Addendum #1

Project: EB Frink Middle School
405 N. Charles Street
LaGrange, NC 28551
Lenior County, NC

Date: March 5, 2024

Item #6: SFL+a Addendum (39 Pages)

1 ENLARGED PLAN - TYP SCIENCE CLASSROOMS
A-411 SCALE: 1/4" = 1'-0"

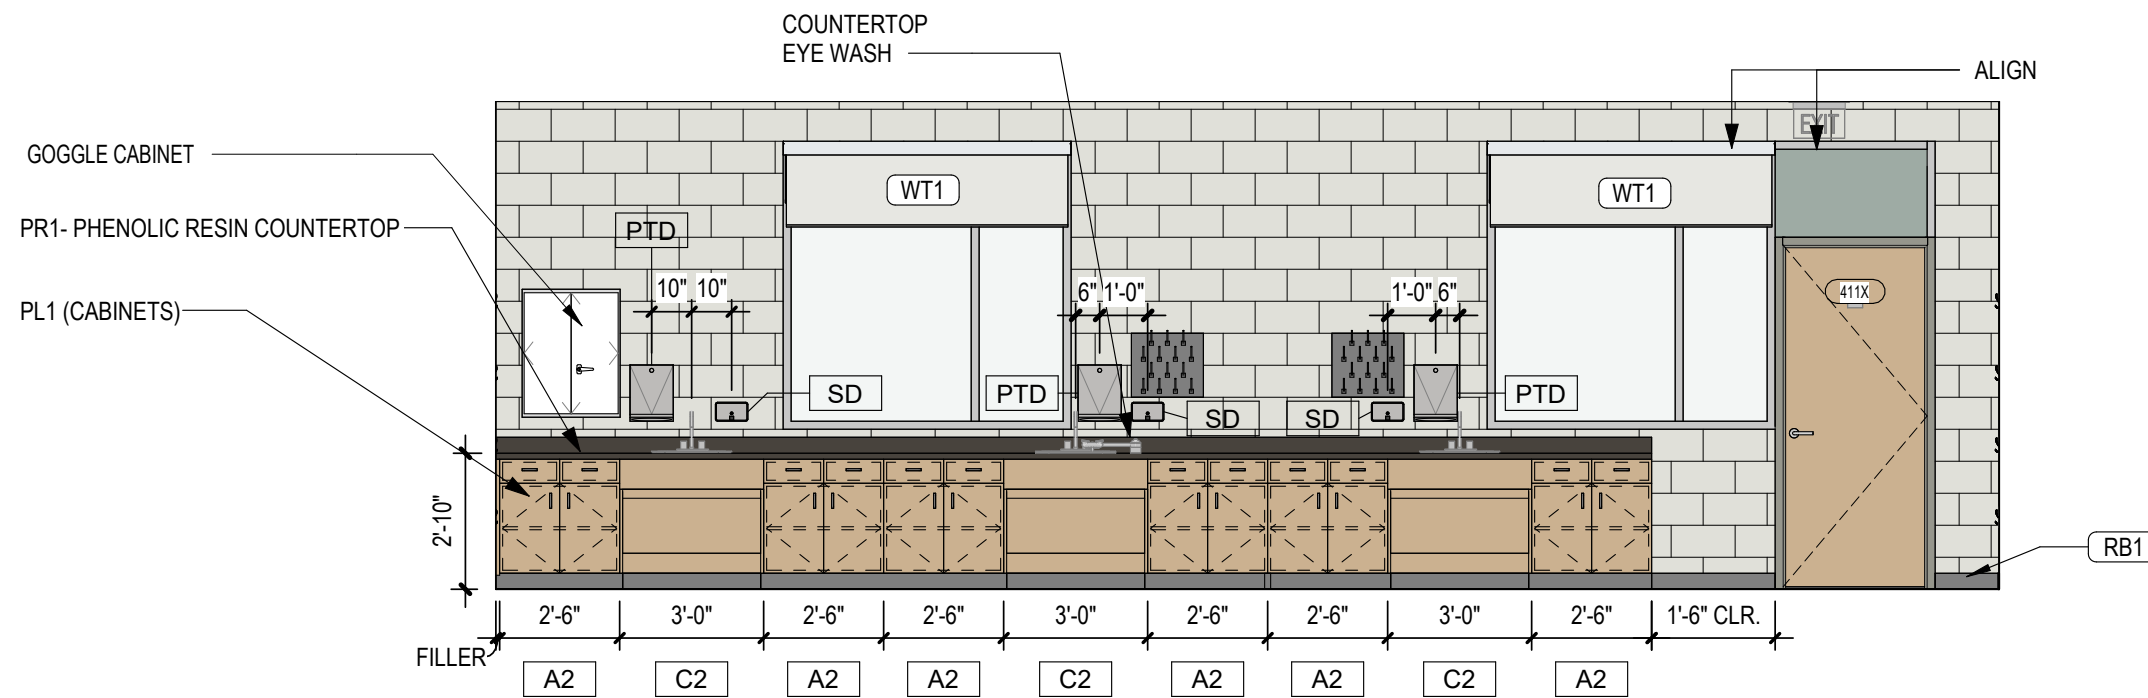
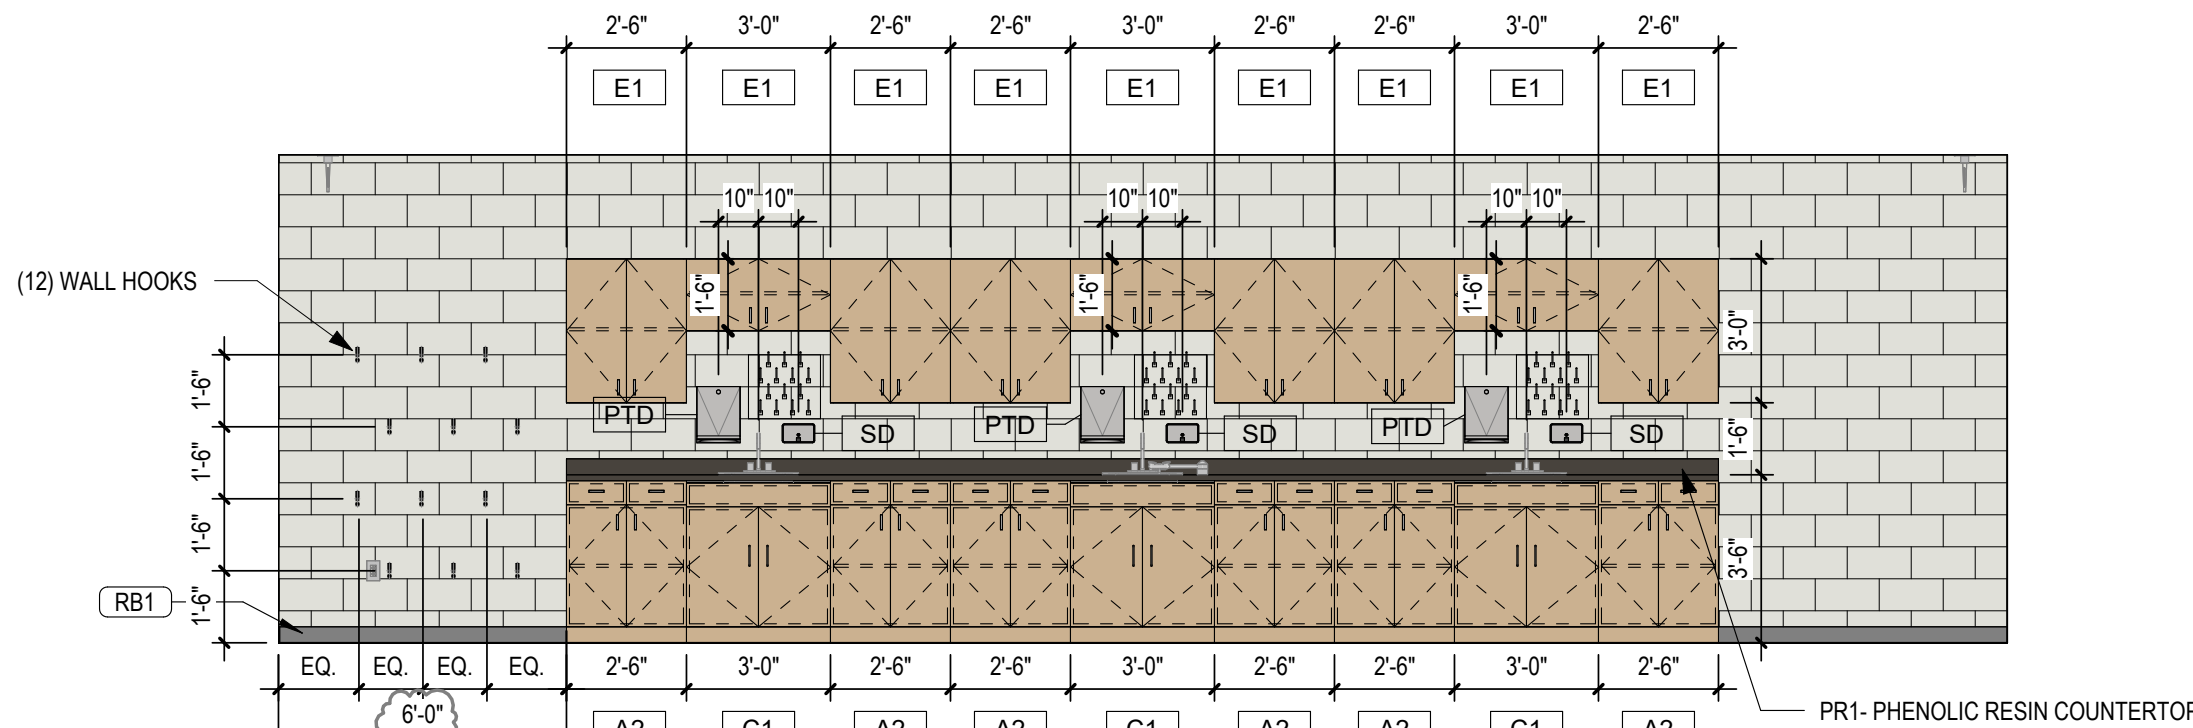
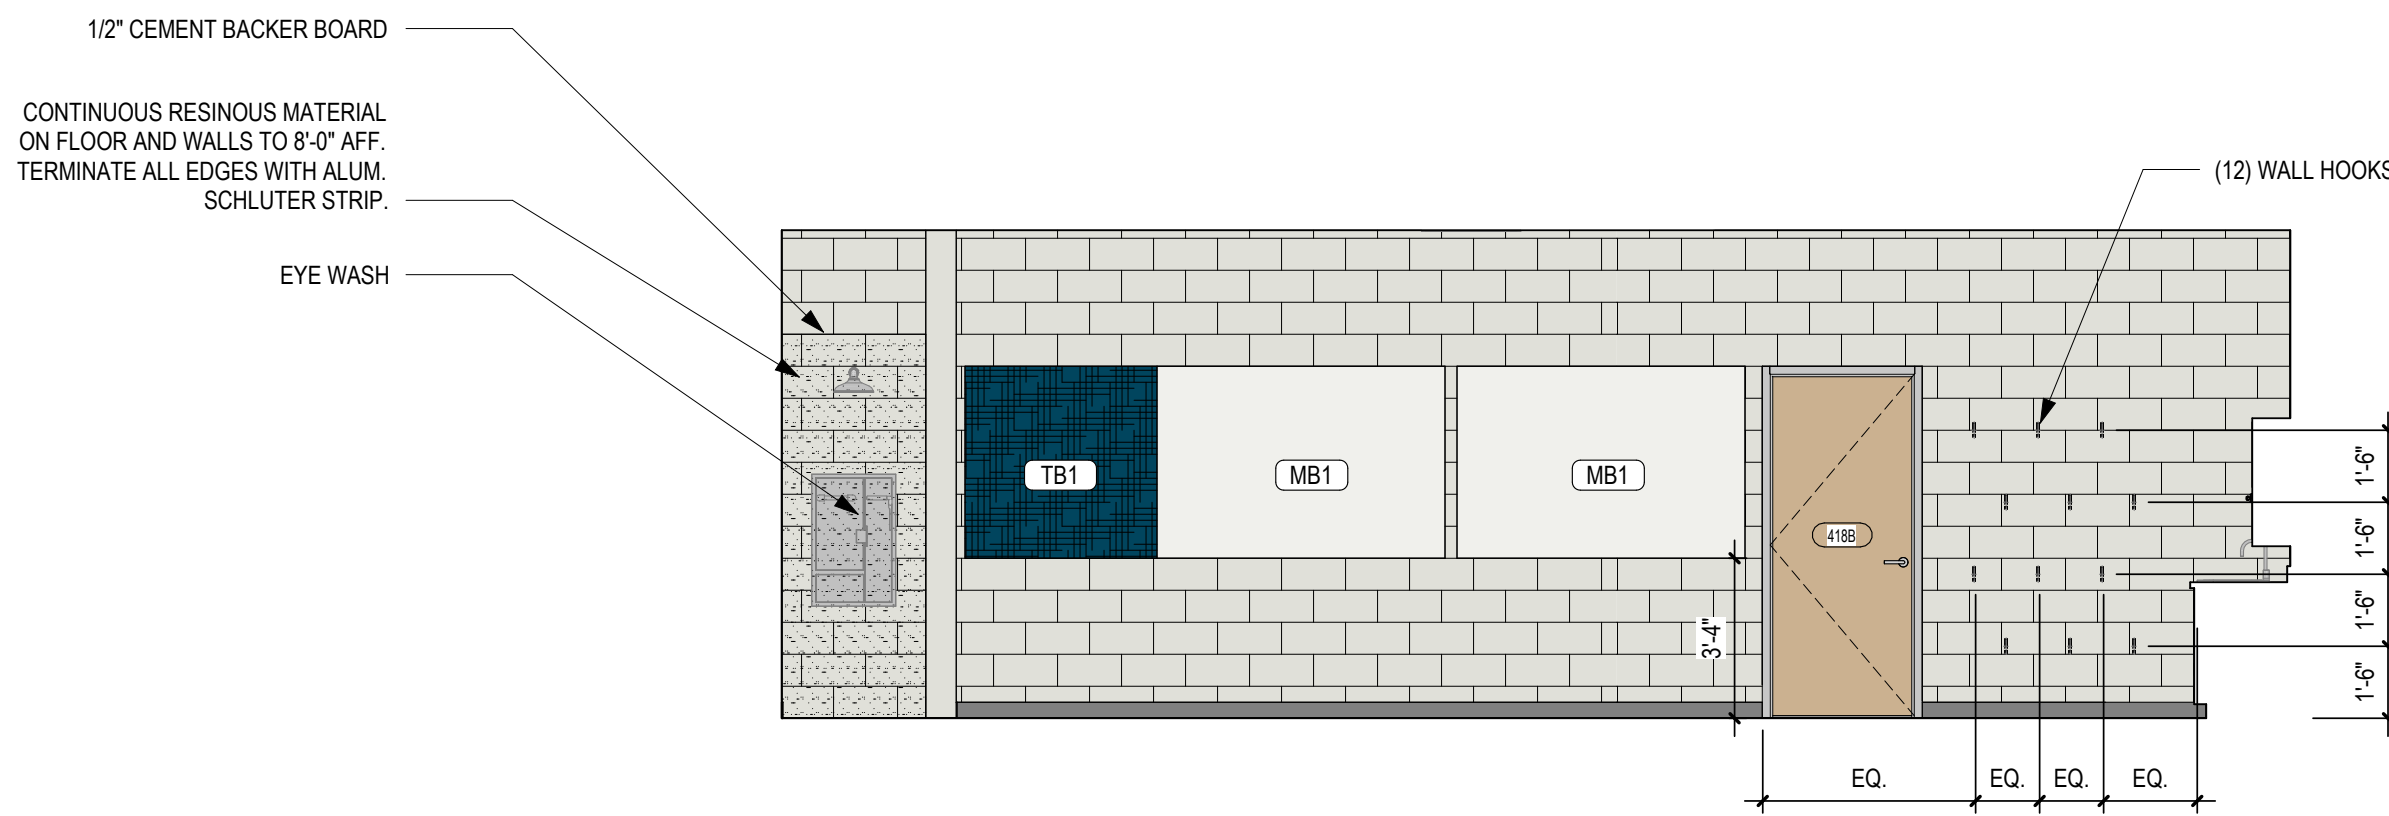
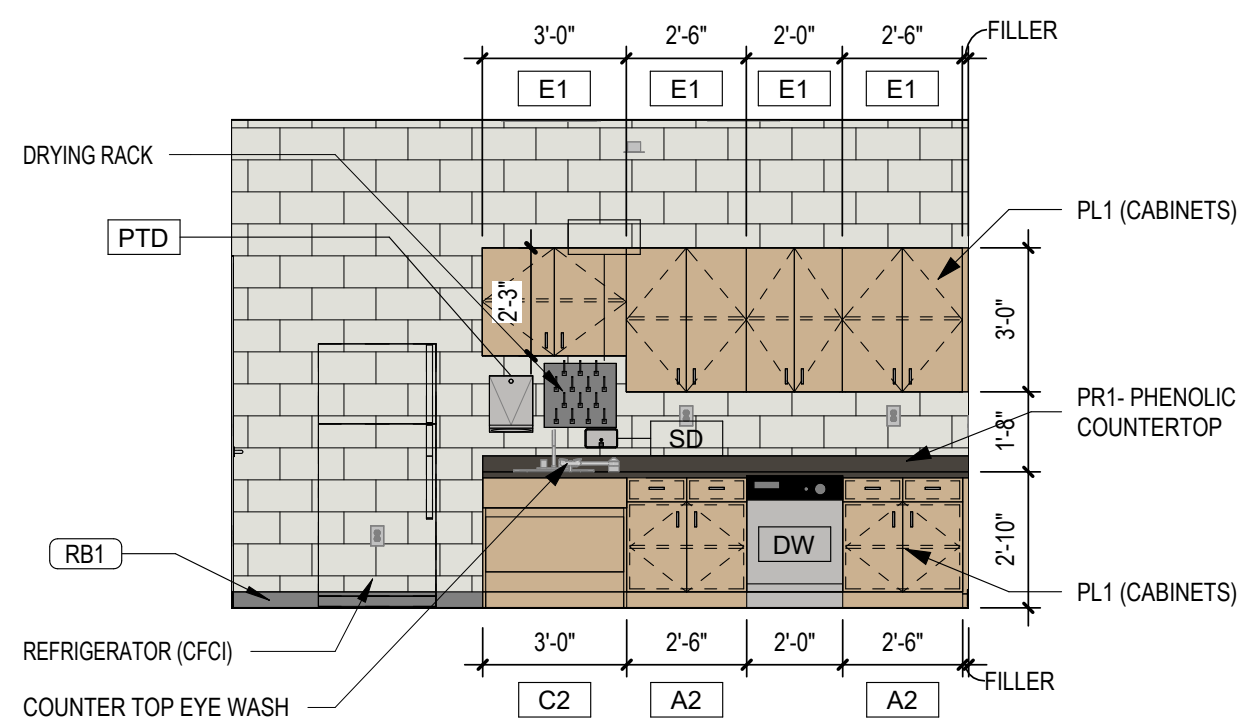
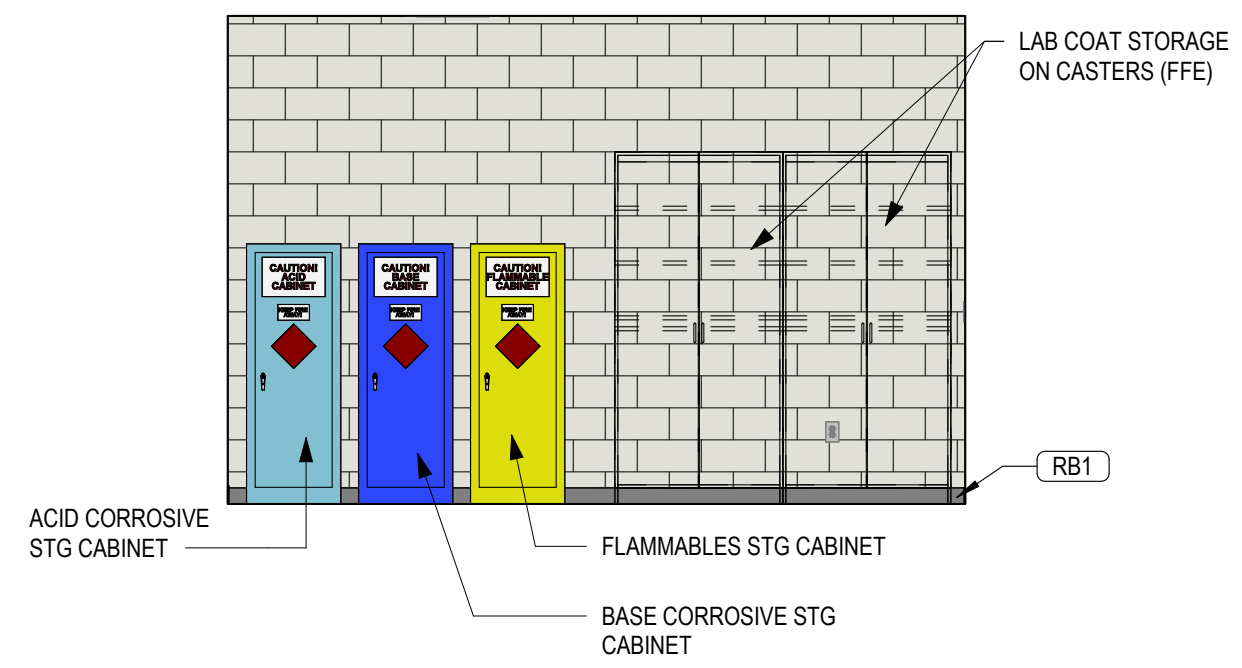
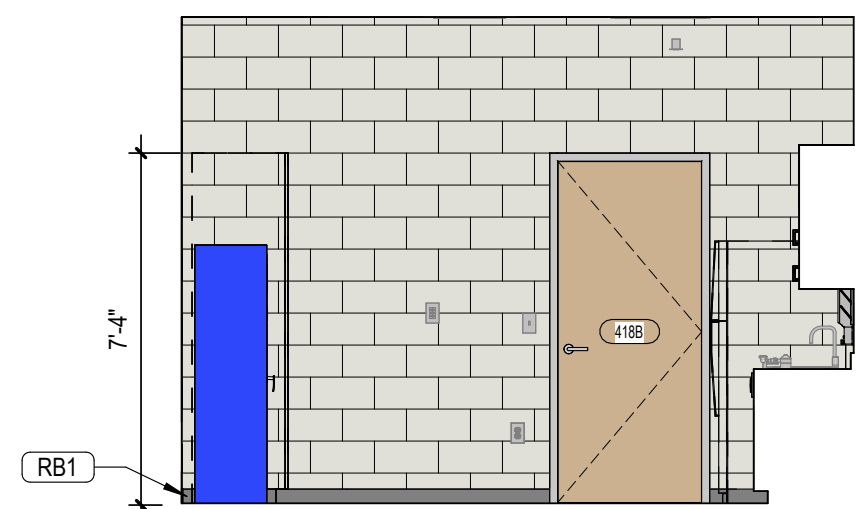
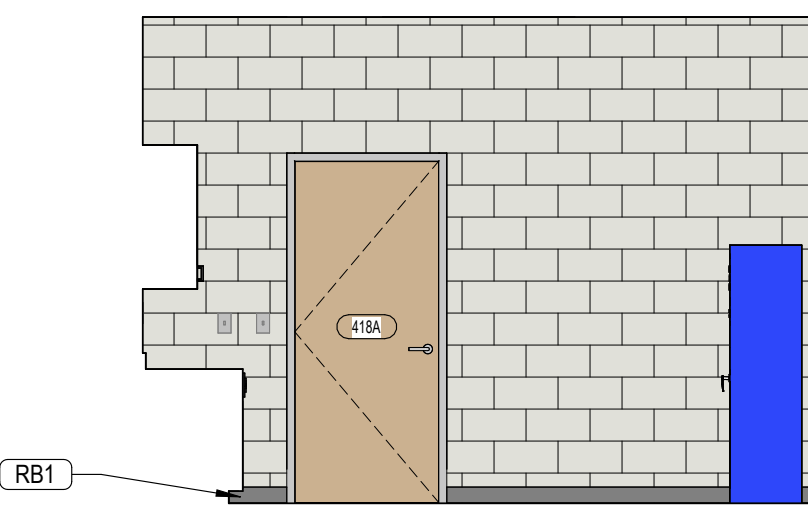
- **Answer: Dimensions shall be coordinated in a forthcoming addendum.**
- Item #9. **Question:** In reference to detail 8 on A-411 the casework does not show a clear dimension off of the adjacent wall. Please provide

- Item #7. A-010:
- L8A6 Wall type removed from sheet.
- Item #9. A-411:
- Dimension added for casework.
- Item #11. A-201:
- Dimensional letters added to exterior.
- Item #20. A-713:
- Flooring revised for eyewash station
- A-714:
- Flooring revised for eyewash station
- A-715:
- Flooring revised for eyewash station
- Item #24. A-711
- Flooring revised for gym storage.
- Item #25. A-432
- Detail 16 removed for clarity.
 - Detail 1: Roof protection removed - not in scope of work.
